TVHS Murfreesboro - Replace Chiller and Cooling Tower VA Project # 626A4-14-201 Addendum #1 05-26-2016

This Addendum, dated 5-26-2016, serves to clarify, revise, and supersede information in the Project Manual, Drawings, and previously issued Addenda. Portions of the Addendum affecting the Contract Documents will be incorporated into the Contract by enumeration of the Addendum in the Owner/Contractor Agreement.

REVISIONS TO DRAWING SHEETS:

- - - E N D - - -

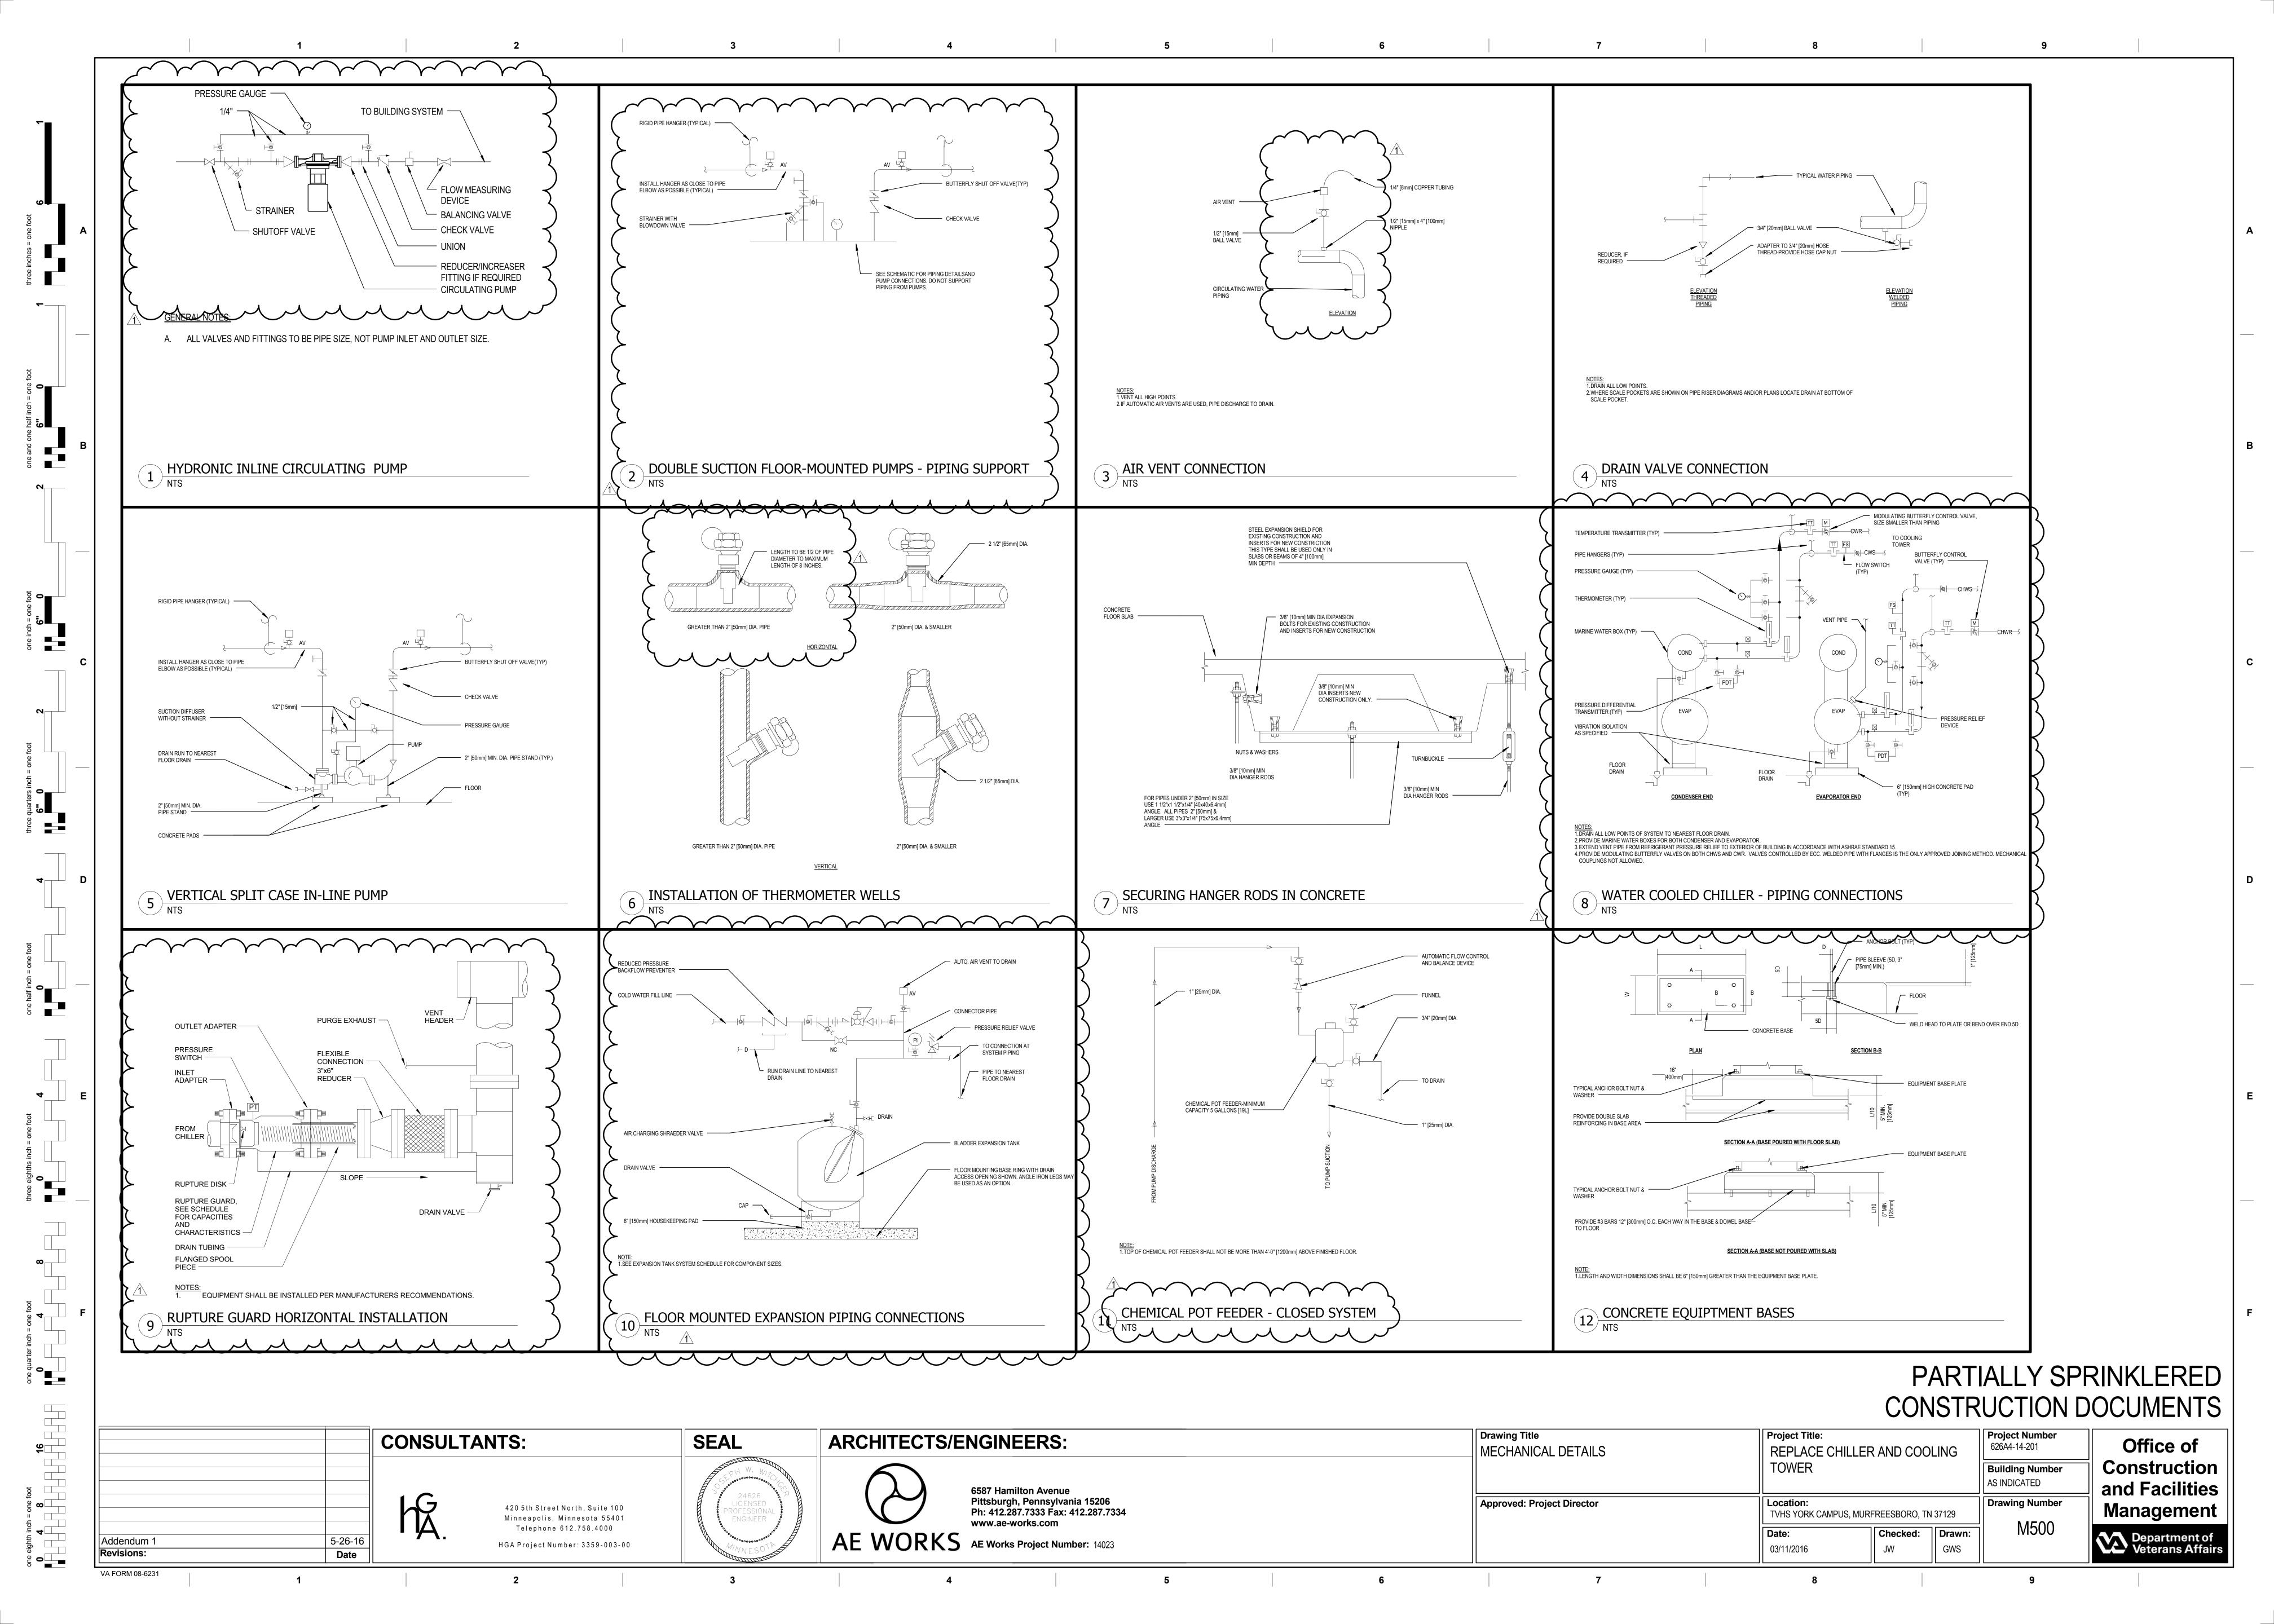
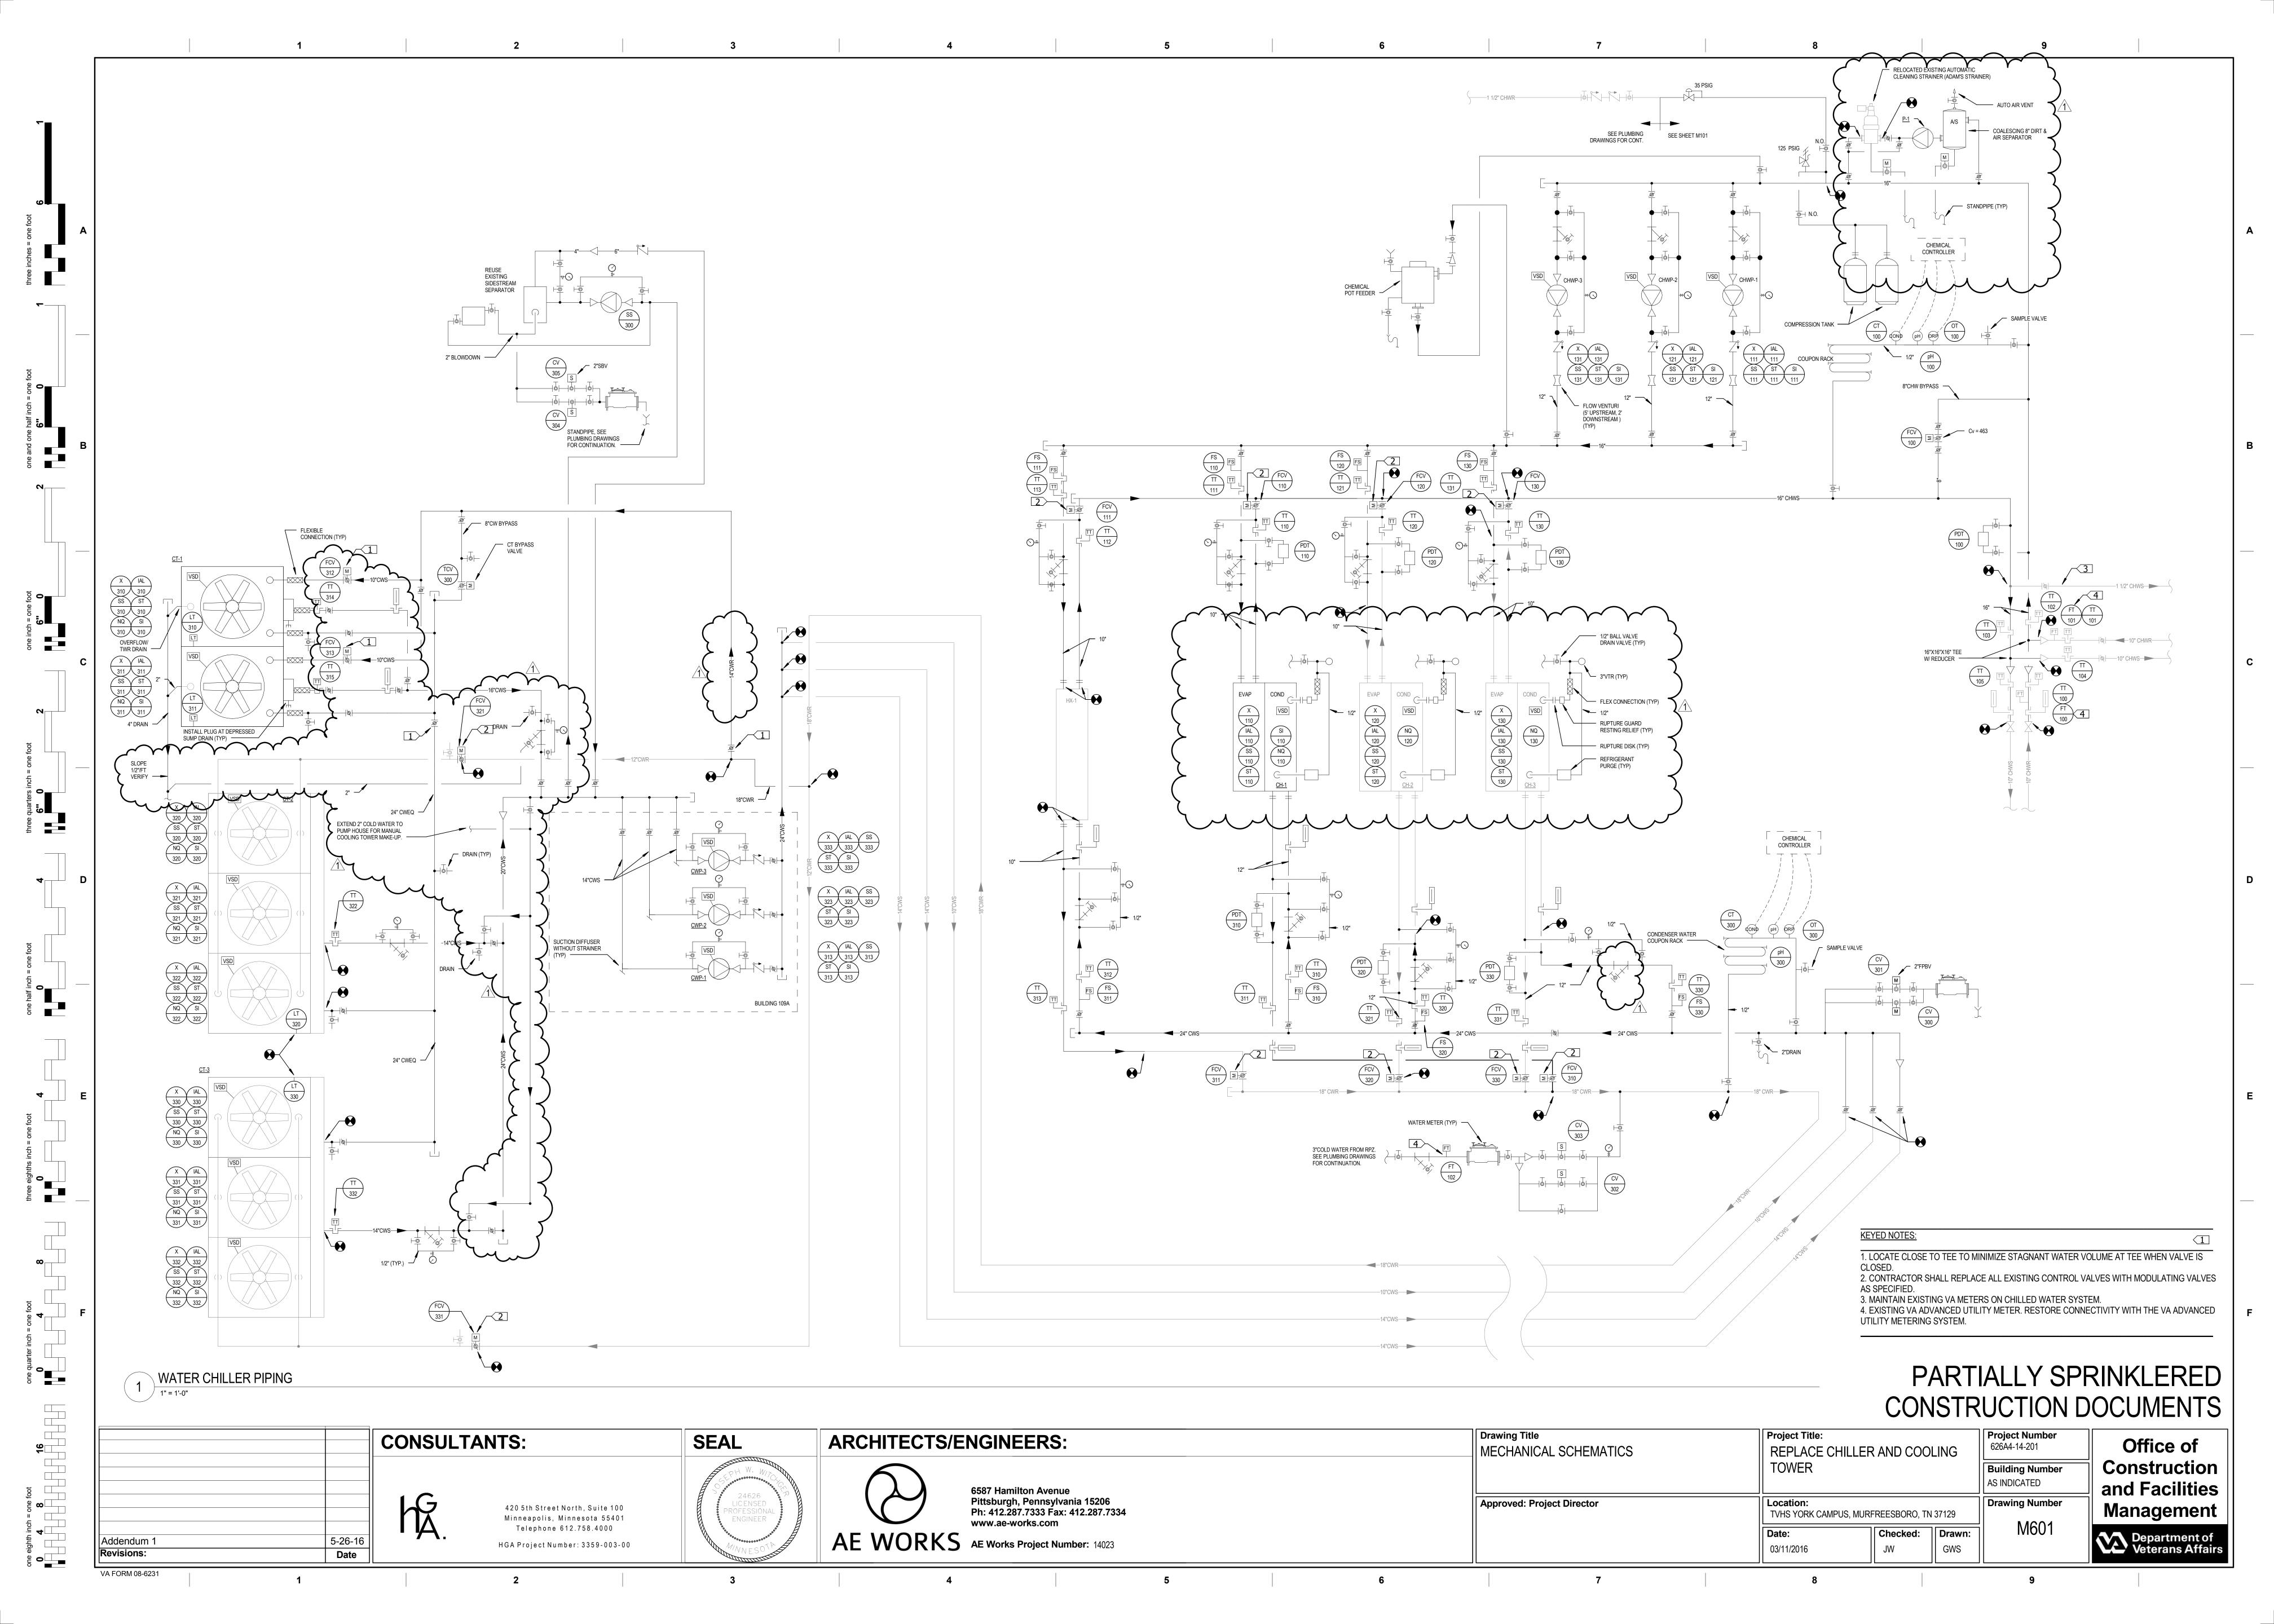
1. Relocated Adams strainer includes relocating drains, controls identified on plans. Clarification of new air separator and piping made to 6/M101.

- 1. Top of new cooling tower sumps must be equal to top of existing cooling tower sumps. See added note to document.
- 2. New reducer may be required depending on location of buried 18x12 reducer underground at towers. Contractor to field verify.
- 3. Modification of flexible metal shielded expansion devices will be used at towers. Change shown on drawing.
- 4. CWR and CWS pipe sizes switched. Piping shown as 14" CWR and 16" CWS on drawing.
- 5. Manual water make up shown on schematic (M601) added to drawing.

- 1. Installation of equipment must be installed in accordance with manufacturer's requirements. Changes to details for compliance shown.
- 2. Refrigerant venting depends on chiller selected. R-123 chiller shall use Trane Rupture Guard safety valve. See detail 9/M500 for revised requirement.

3. Snubbers are not required at pressure gages as called out, utilize ½" ball valves as shown on details.

- 1. Air separator to include auto air vent isolated by manual ball valve, drain with blowdown valve.
- 2. Modifications to match changes made to plan and details.

1. Modify cooling tower schedule as shown. Equipment TOTAL NOMINAL CAPACITY does not change, number of cells and flow per cell updated to match actual.
